Access Compliance Report

Public Rights-of-Way

Intersection ID: 17009	Main Street: N_WENDOVER_RD	Cross Street: RANDOLPH_RD	Location: N
ADA ID: 9054DB2DB2FA	Ramp Type: Perp	Initial Pass/Fail: Fail	Overall Compliance: No
			Severity Score: 18.75

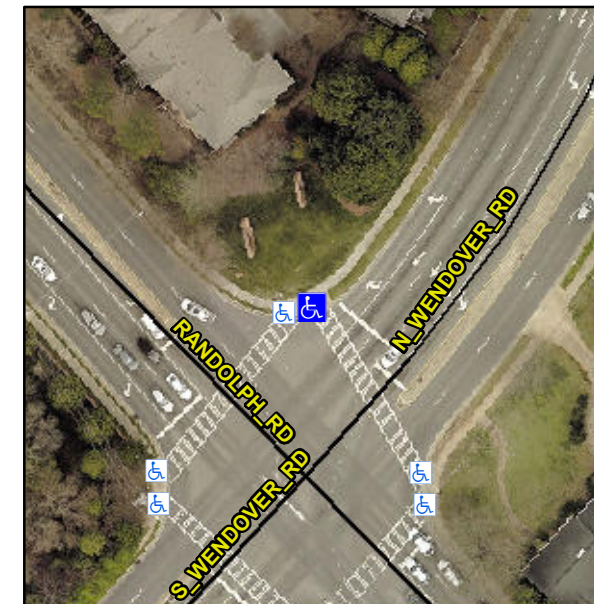
Not Found, R304.5.1, R304.5.3

Compliance	Description	Data	Compliance	Description	Data
N/A	Ramp Length (in)	131.0	Yes	Ramp Slope (%)	6.5
No	Ramp Width (in)	34.5	No	Ramp XSlope (%)	4.9
N/A	Flare Type LT	N/A	N/A	Flare Type RT	N/A
N/A	Flare Slope LT (%)	N/A	N/A	Flare Slope RT (%)	N/A
N/A	Flare Traversable LT?	N/A	N/A	Flare Traversable RT?	N/A
N/A	Landing Length (in)	N/A	N/A	DWS Provided?	N/A
N/A	Landing Width (in)	N/A	N/A	DWS Contrast?	N/A
N/A	Landing Slope (%)	N/A	N/A	DWS Length (in)	N/A
N/A	Landing X Slope (%)	N/A	N/A	DWS Full Width?	N/A
N/A	Landing Curb? (Y/N)	N/A	N/A	DWS Offset (in)	N/A
N/A	Shared Landing?	N/A			
N/A	Gutter Ponding?	N/A	N/A	Gutter Slope (%)	N/A
N/A	Gutter Lip Ht (in)	N/A	N/A	Gutter X Slope (%)	N/A
N/A	Painted X Walk1?	Yes	N/A	Painted X Walk2?	N/A
	X Walk 1 Direction	To SE		X Walk 2 Direction	N/A
N/A	X Walk 1 Width (in)	104.0	N/A	X Walk 2 Width (in)	N/A
	X Walk 1 Slope (%)	0.7		X Walk 2 Slope (%)	N/A
	X Walk 1 X Slope (%)	3.4		X Walk 2 X Slope (%)	N/A

Remove & Replace Entire Ramp.
